TECHNICAL BULLETIN

STEERTEK™ NXT • STEERTEK™ Tie Rod Assemblies

SUBJECT: Tie Rod Assembly Replacements &
Tie Rod End Component Service Kits

LIT NO: SEU-0223

FIGURE 1

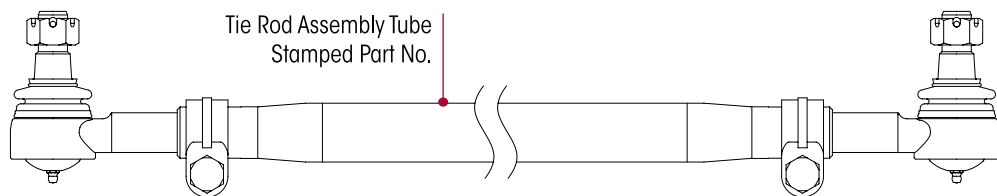
The tie rod assemblies originally equipped on STEERTEK NXT and STEERTEK axles **prior to 2014** use the tie rod end component style shown in Figure 2. **For service purposes**, note these prior tie rod assemblies are not compatible with any current tie rod assemblies introduced in 2014 (Figure 1). Any necessary service of the prior tie rod end component style will require complete tie rod assembly replacement.
